THREE MILE ISLAND, UNIT 1 (TMI UNIT 1)
OPERATING LICENSE NO. DPR-50
NRC DOCKET NO. 50-289

SUBJECT: Response to NRC Staff Follow-Up Questions 1 through 4 from
November 9, 2001 Meeting Regarding a TMI Unit 1 Steam Generator
Severed Tube

Response to NRC Follow-Up Questions from November 9, 2001 Meeting Regarding the TMI Unit 1 Steam Generator Severed Tube

Figure 1. SEM mosaic of fracture face of TMI-1 tube no. B66-130

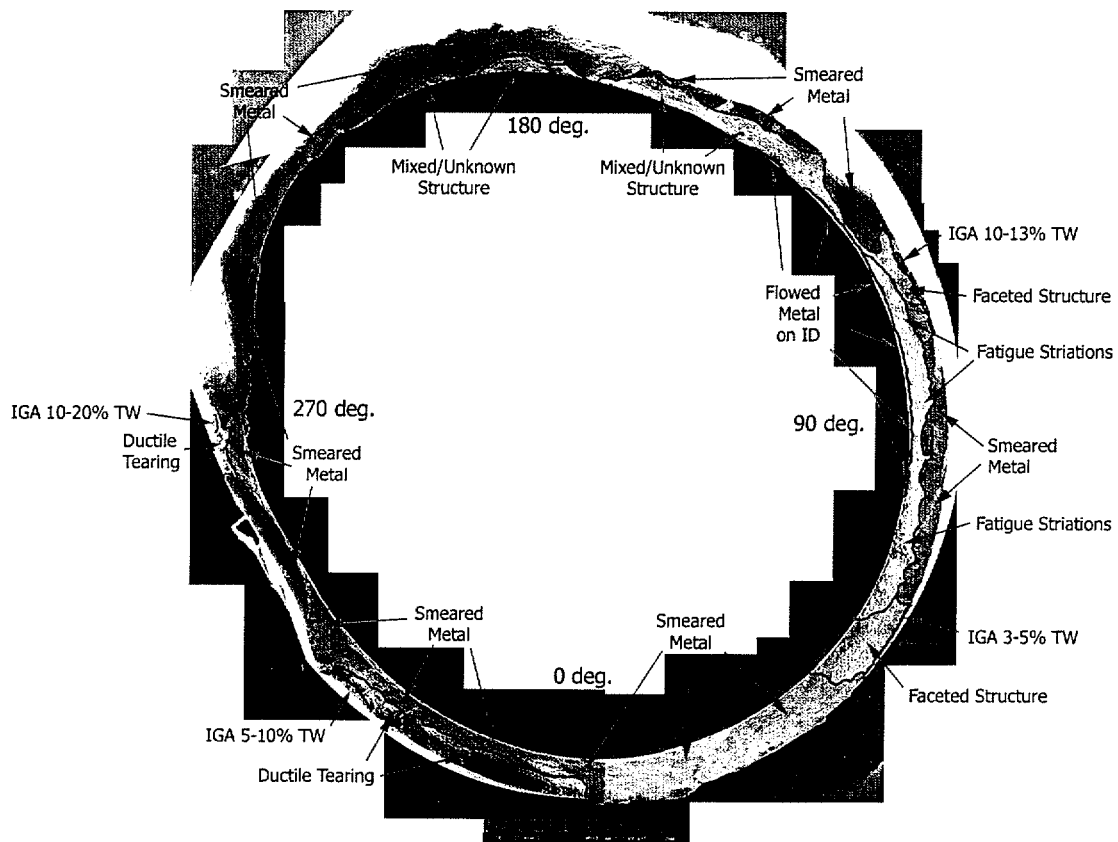
1. Please provide a montage of high magnification fractographs to augment the fracture surface map provided to the NRC staff on November 15, 2001 (which is attached as an addendum to the meeting handout in Enclosure 2). The fractographs should be annotated, including magnification and orientation, and should describe the significant features of the fracture surface. The fractographs should demonstrate examples of the features identified on the fracture surface map (e.g, IGA, fatigue striations, pueblo structure, flowed metal, ductile tearing and smeared metal). Provide a discussion of the fracture surface features as they relate to the postulated failure sequence of events, i.e., outer diameter (OD) IGA as points of origin for fatigue propagated by flow induced vibration, followed by ductile tearing.

A low-magnification Scanning Electron Microscopy (SEM) mosaic of the entire fracture surface is shown in Figure 1. As can be seen in Figure 1, much of the fracture surface was smeared, or burnished, by the rubbing of the fracture surfaces against each other during the failure process. After the tube separated, additional fracture surface was lost by abrasion when the tube rubbed against the adjacent tubes. Nevertheless, it was possible to identify several regions of OD intergranular attack (ODIGA), fatigue damage, and ductile tearing. These regions of interest are identified in Figure 1. In the discussion that follows, reference is made to several SEM fractographs to illustrate the regions of specific damage. In all of the fractographs presented, the vertical orientation of the images is preserved with respect to Figure 1; i.e., the 0° reference is toward the bottom of the figure, and the 180° reference is toward the top of the figure. Rotational orientation is counterclockwise from the 0° reference.

Figure 1. Etched cross-section of expanded section of tube no. 65-130 showing the presence of ODIGA (500X)

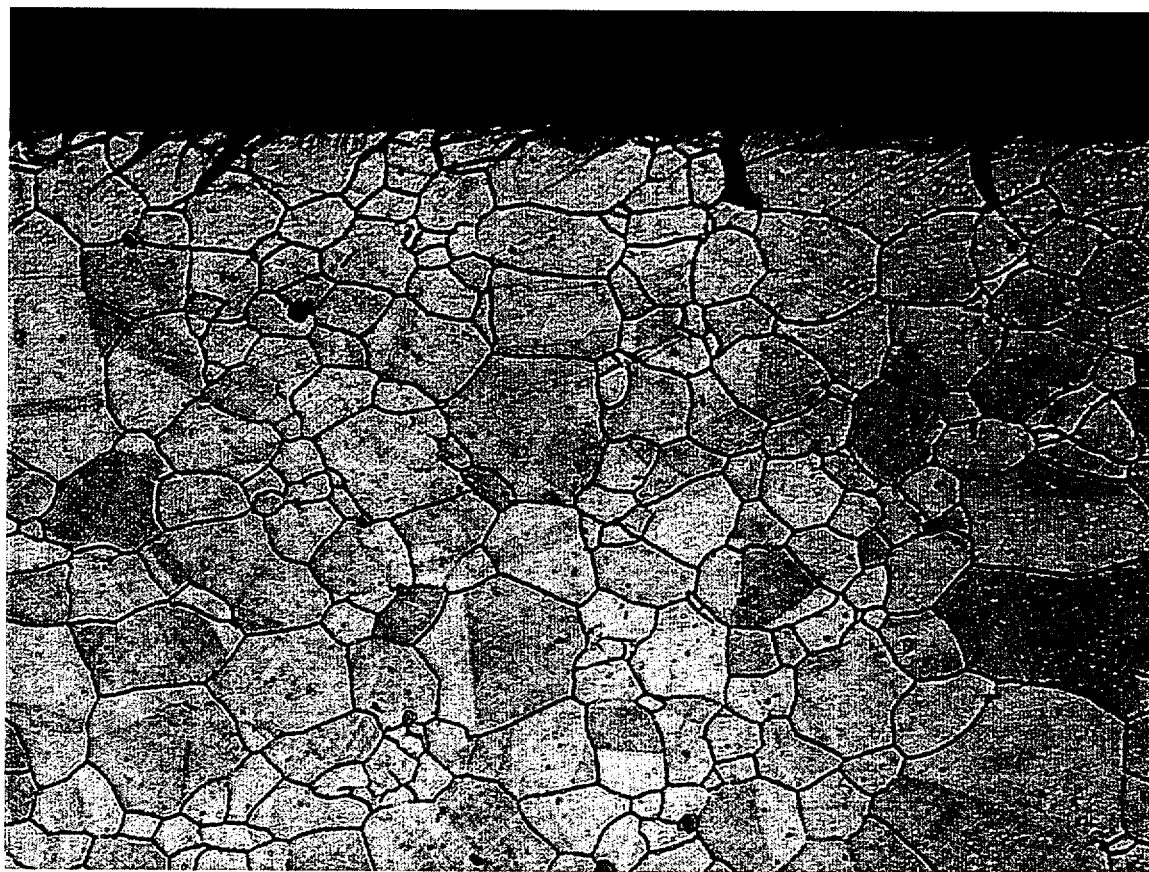
2. Summarize the results of the metallography, hardness measurements, and mechanical testing that have been completed on the severed tube and other harvested tubes. Describe the locations of the test specimens (or hardness tests) relative to the fracture surface location. Relate these results to the postulated failure mechanism.

A sample of tubing removed from approximately 13 – 27 inches below the upper tube sheet face, tube 65-130, was hydraulically swelled approximately 8.6% from 0.626 to 0.680 inches OD at a pressure of 9,784 psi. A photomicrograph of the expanded portion of the tube shows shallow ODIGA 1-2 grains deep (Figure 1). This is typical for tubing in the steam space of B&W OTSGs. No other microstructural anomalies were observed and the microstructure is typical of sensitized Alloy 600 tubing, with carbide decoration of the grain boundaries.
